TRANSMITTAL OF THE REMEDIAL INVESTIGATION/FEASIBILITY STUDY (RI/FS) WORK PLAN FOR THE 200-ZP-1 GROUNDWATER OPERABLE UNIT, DOE/RL-2003-55, REVISION 0

**COMMENT RESPONSES –
DOE/RL-2003-55, DRAFT A, 200-ZP-1 OPERABLE UNIT WORK PLAN**

Draft Resolution of 2nd Set of EPA comments resolution from received during -6-22-04 Meeting, 200-ZP-1 Work Plan, DOE/RL-2003-55, Rev 0

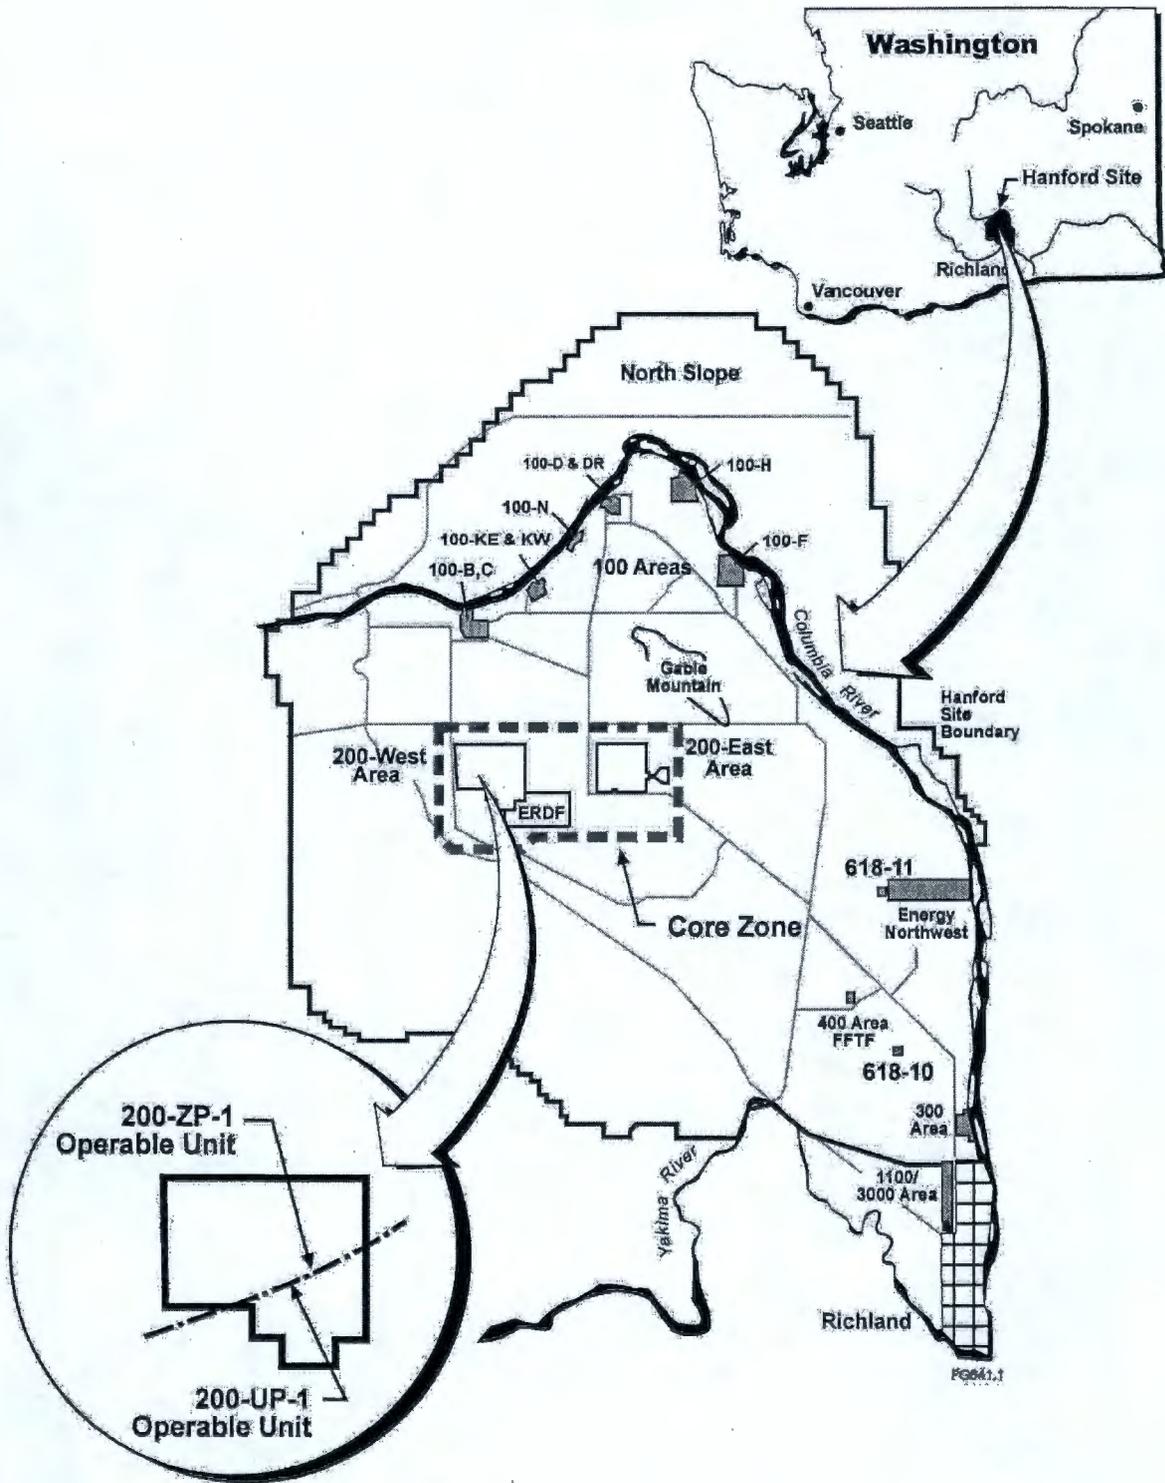
Document Location	Comment	Proposed Resolution
1.	RL	Page 1-2, Figure 1-1	Please revise figure to show the 200-ZP-1 Operable Unit.	The figure will be revised to show the dividing line that separates the 200-ZP-1 OU from the 200-UP-1 OU. The north-pointing arrow and foot/meter scale have been removed from the figure in order to avoid the document being designated as "Official Use Only." Attached is an example of how the new figure will appear.
